Planning & Zoning Memo

TO: Planning and Zoning Commission
FROM: Alex Pfaltzgraff, Development Services Director
DATE: May 4, 2020
RE: 1884 SE Destination – Site Plan Amendment

Planning & Zoning Staff Report

TO: Planning and Zoning Commission
FROM: Evann Martin, Assistant Planner
DATE: May 5, 2020
RE: M-KEDS Home Place Plat 2 Lot 9 – Site Plan

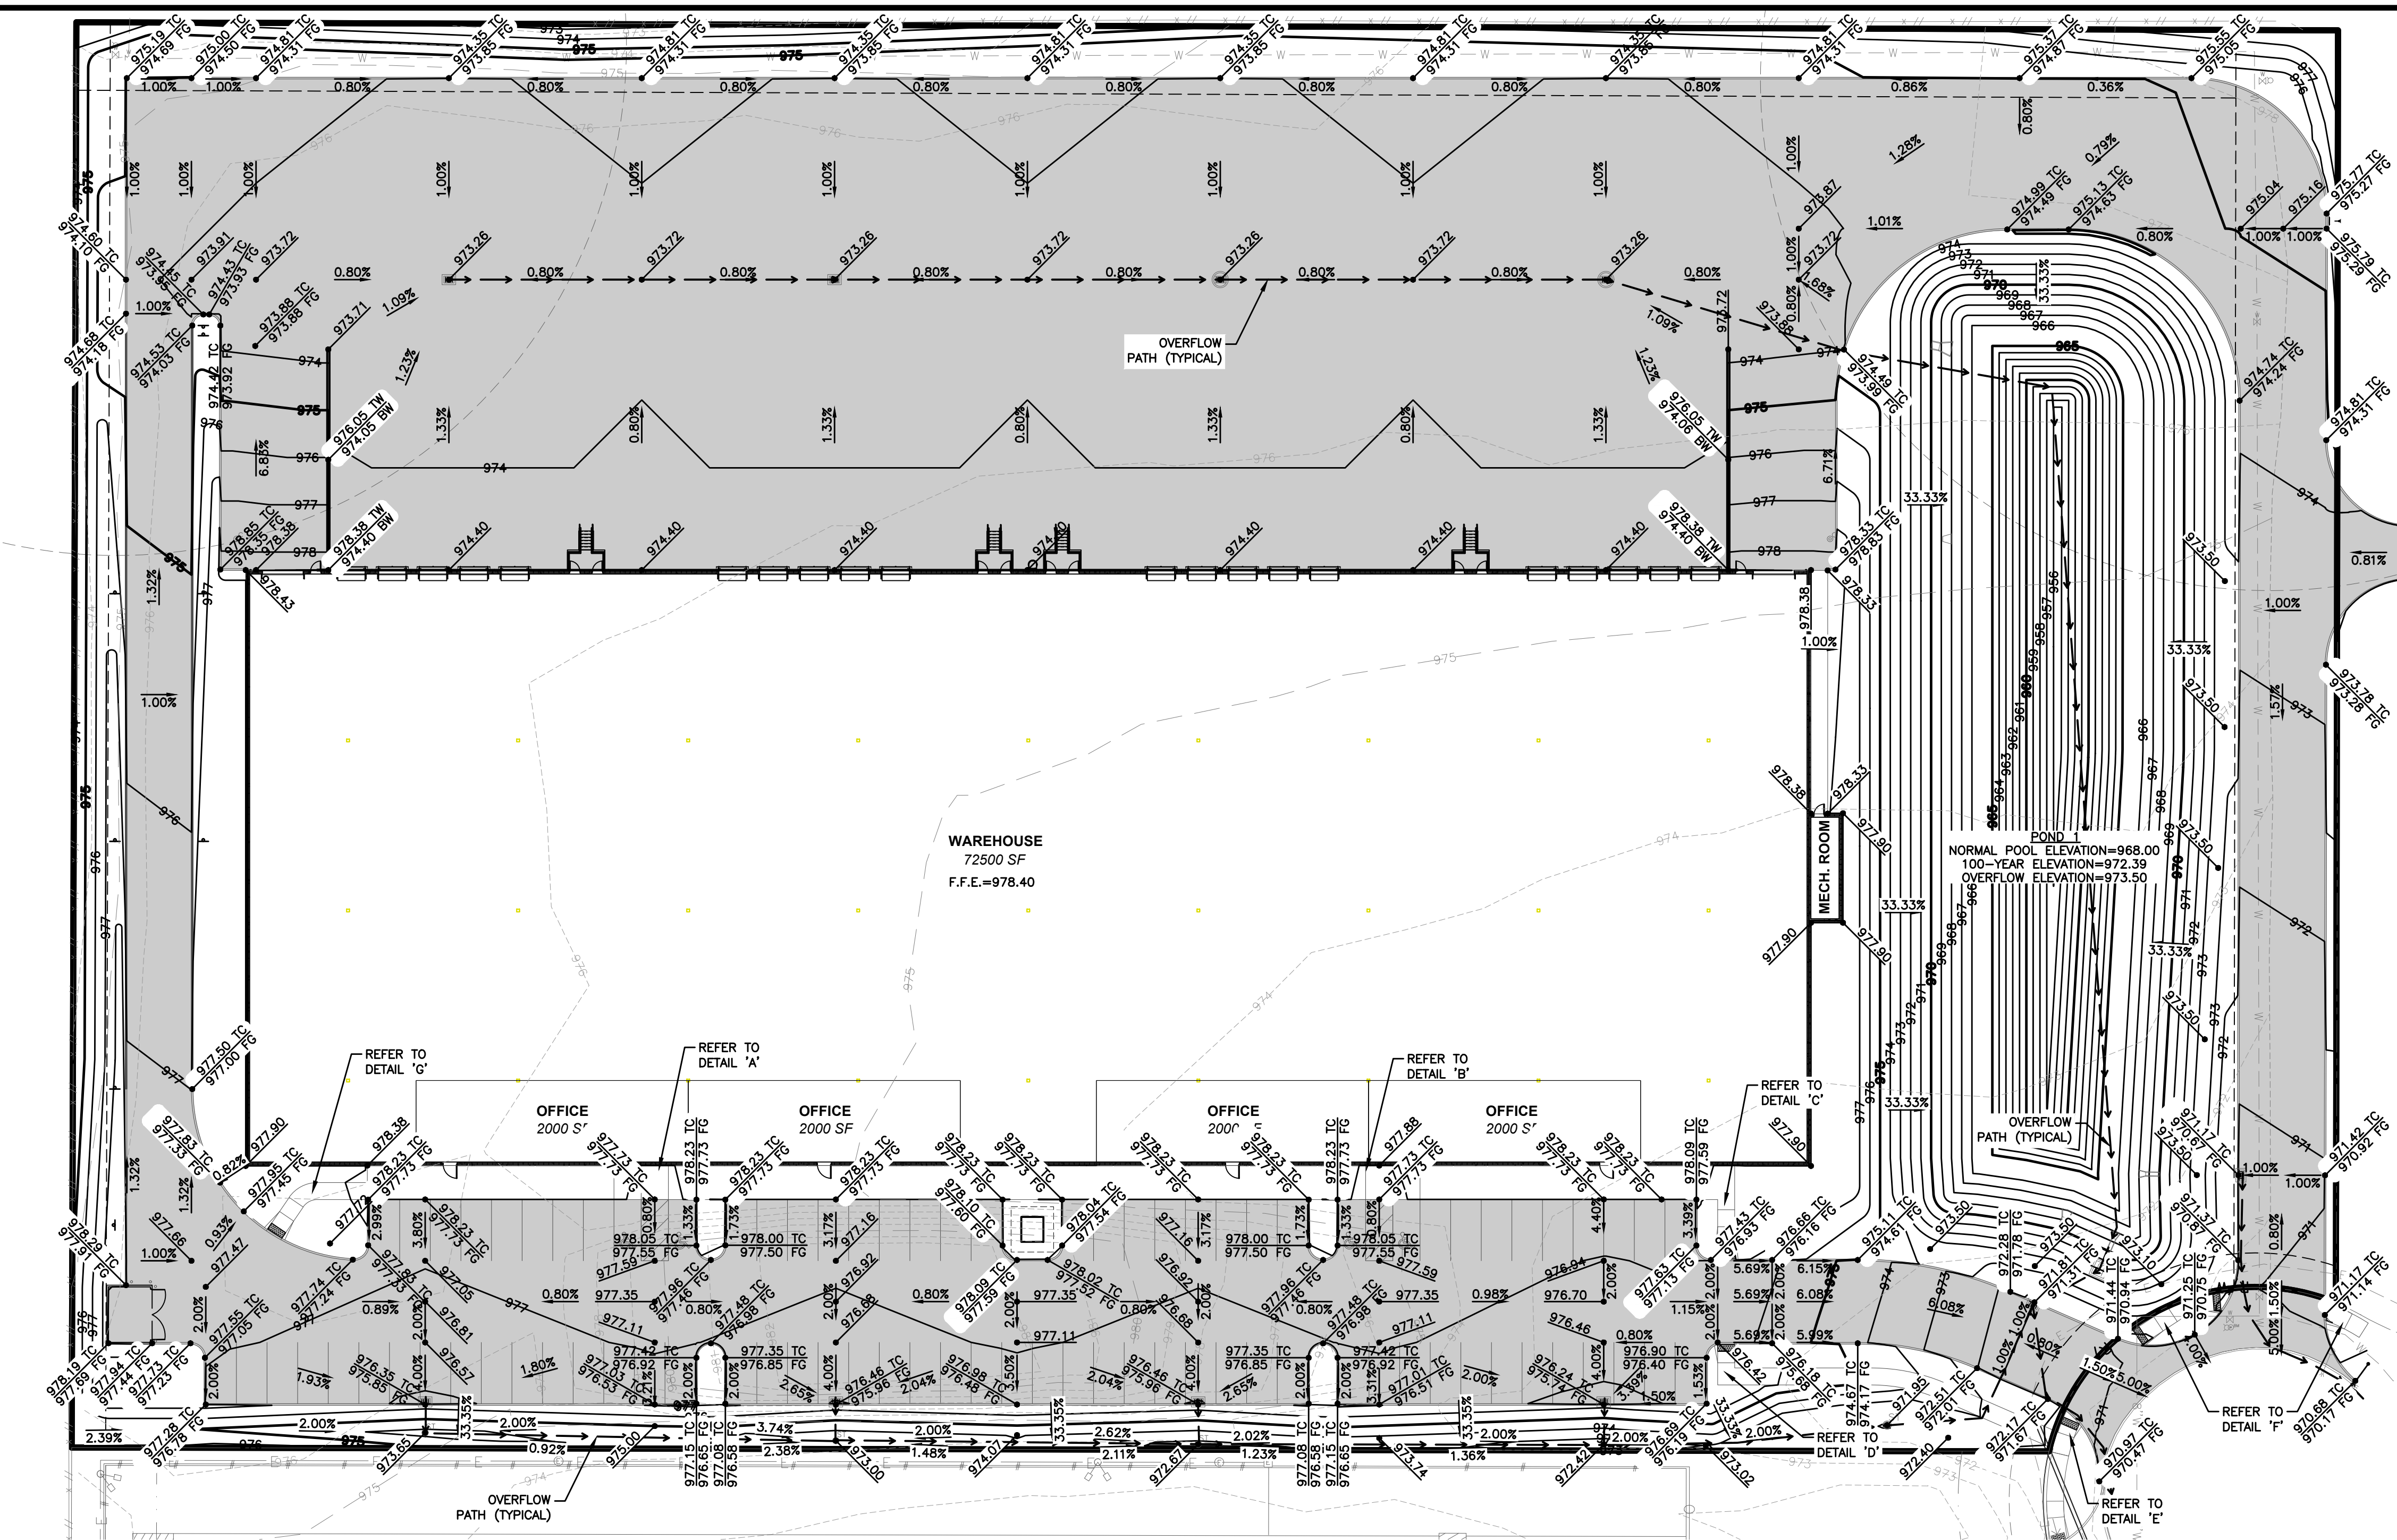
Sheet 3:

- ~~1. Please update the City of Grimes Standard Notes for Site Plans, attached.~~
- ~~2. Please add the driveway location for the Water Tower and show the return. The City will reimburse for the cost associated with the return. Plans attached.~~

- ~~3. Show the width of the loading spaces. They should be 12' wide. Please show that the loading spaces at the docks are 12' wide.~~
- ~~4. Update the building setback line to reflect M-1A setback requirements.~~

- ~~5. Show 5' sidewalk in the ROW, and provide elevations to ensure 1.5% cross slope.~~
- ~~6. Show the future sidewalk as 5'. Staff questions when it will be installed. This sidewalk and the one leading to the dumpster don't scale to 5'.~~

- ~~7. Please provide a detail for the trash enclosure. Staff questions if any additional dumpsters are needed on site.~~
- ~~8. Please increase the width of the western drive to 24 feet, or mark one way traffic.~~

- ~~9. Please extend the sidewalk in front of the building west and then south to provide a pedestrian access to the dumpster enclosure.~~
10. Please add the location of the proposed light poles.

LOT 9 - M-KEDS HOME PLACE PLAT 2
LANDSCAPE PLAN

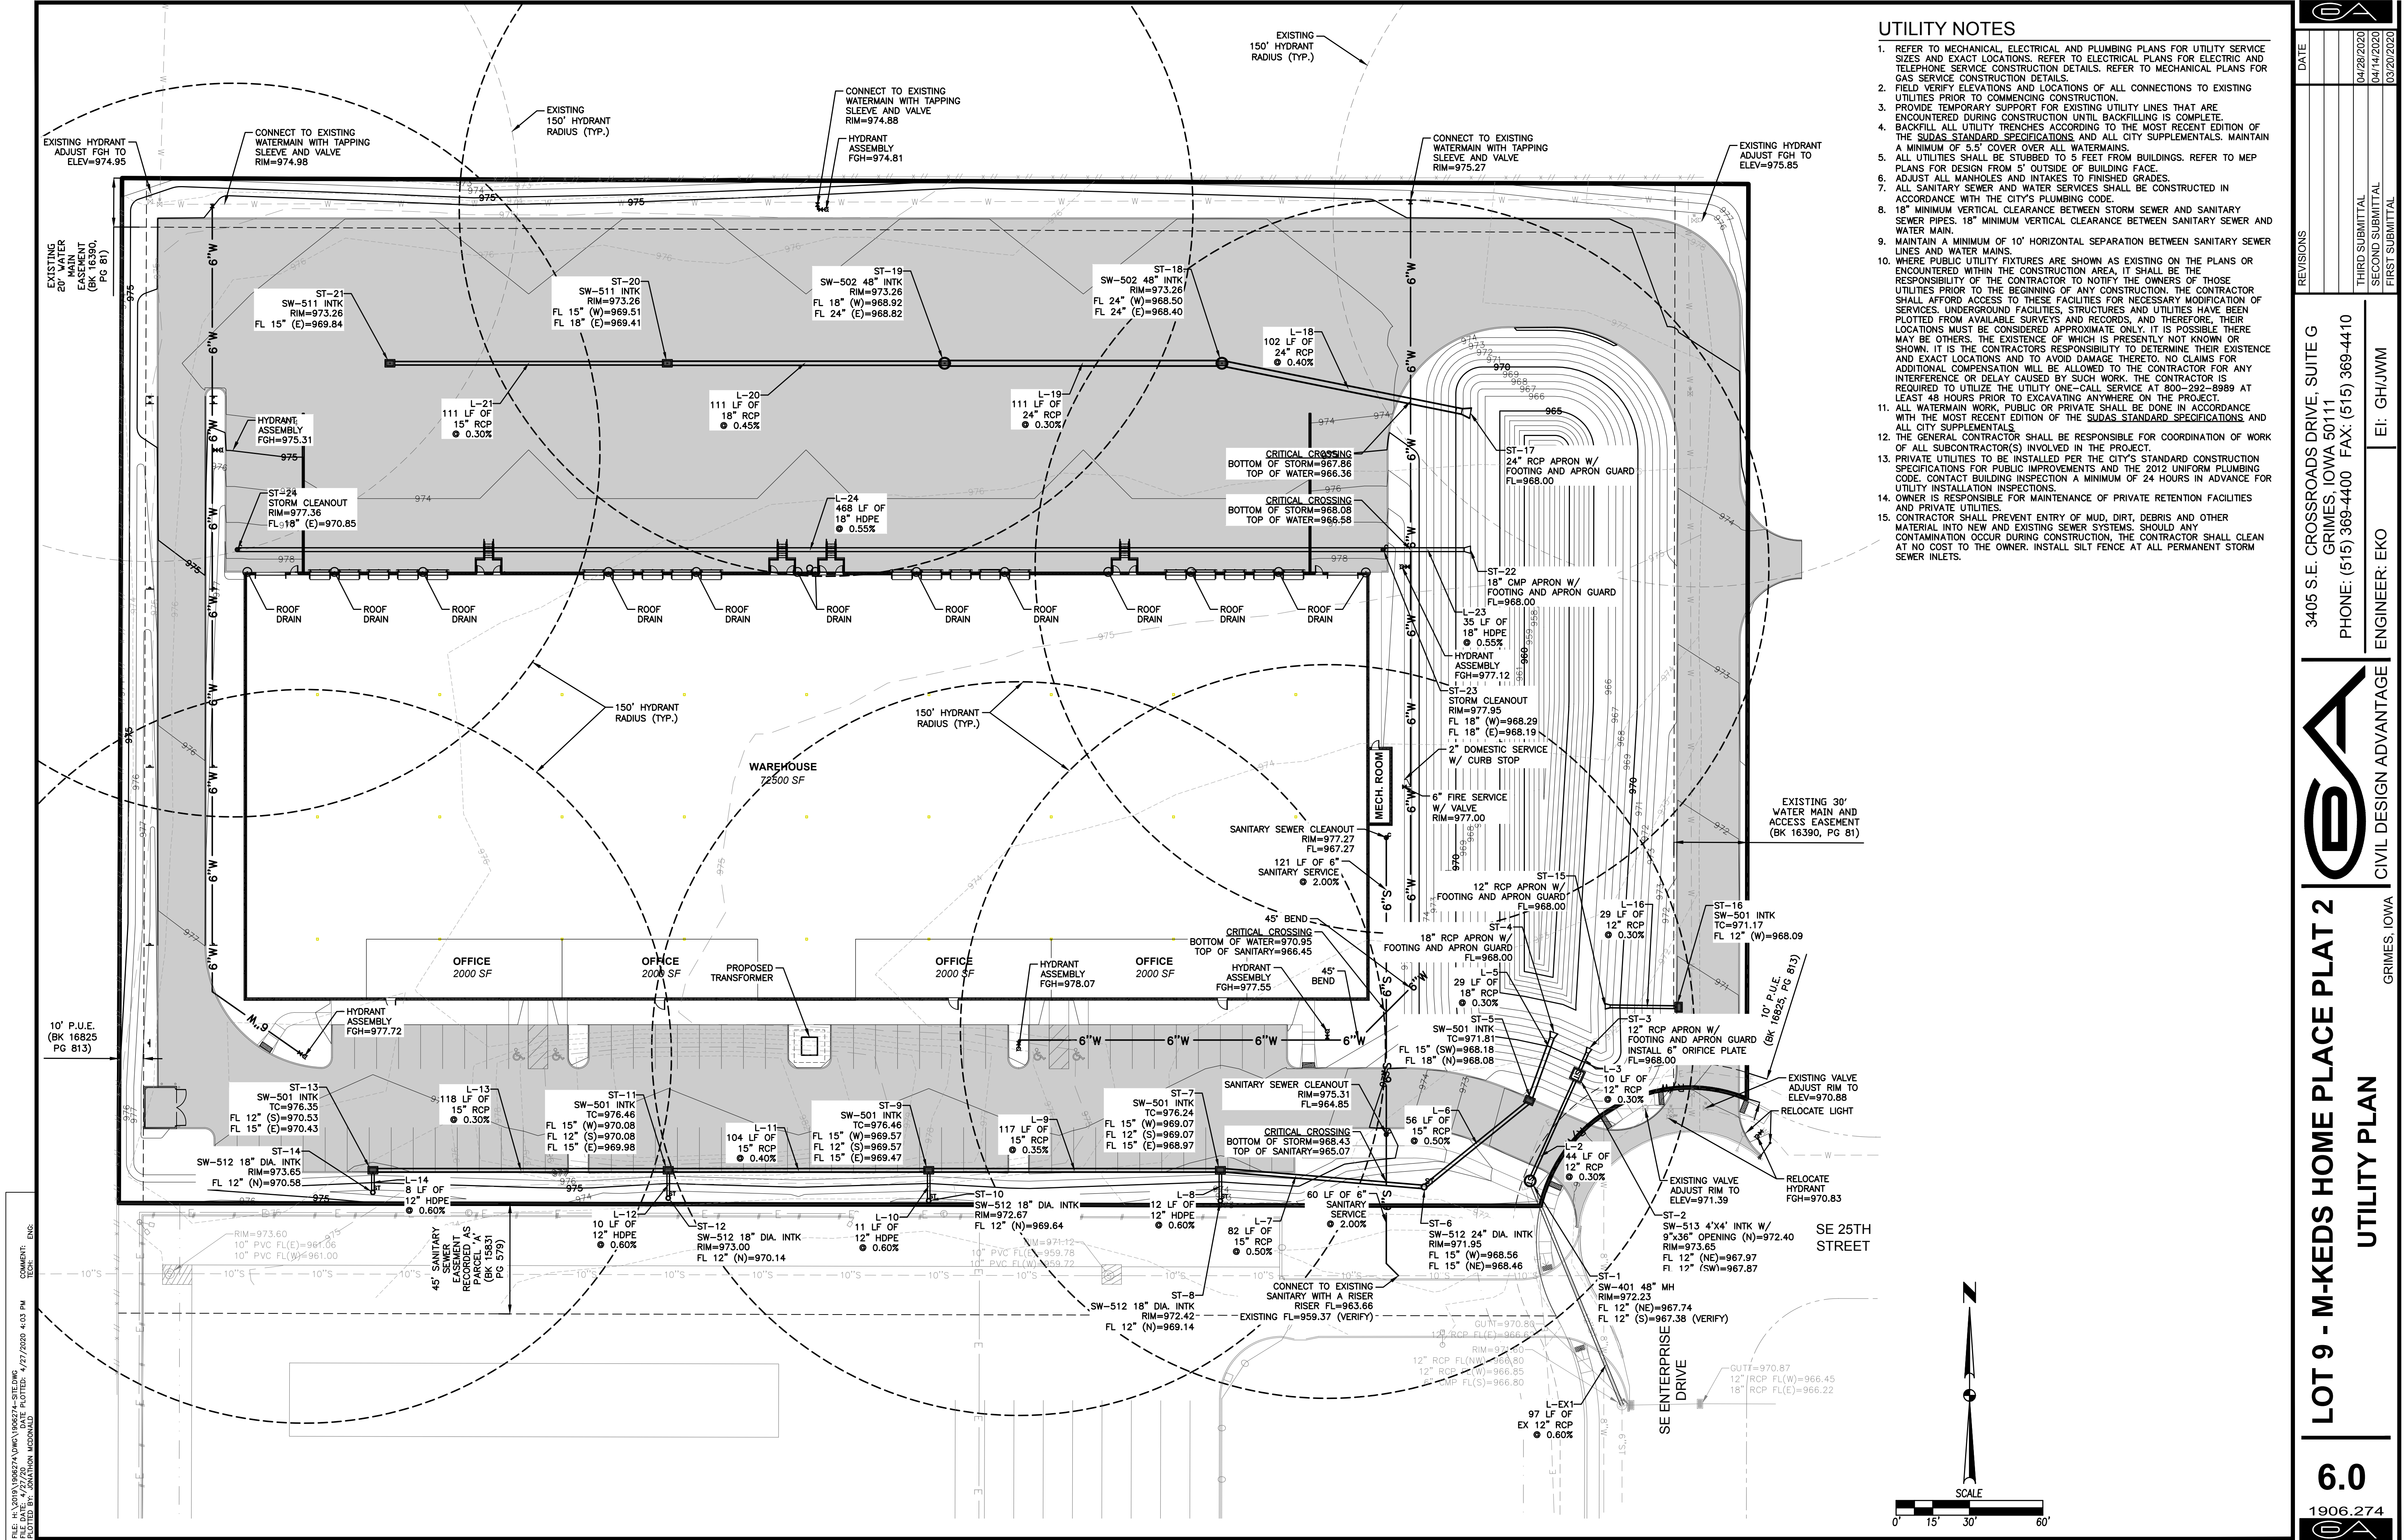
Sheet 7:

- ~~1. Staff would like to see additional landscaping (trees) added along the west property line. The Future Land Use Plan calls for commercial and open space, and therefore the views should be protected.~~
- ~~2. Show the ground cover as sod.~~
- ~~3. Please provide landscaping around any ground mounted transformer and mechanical units.~~
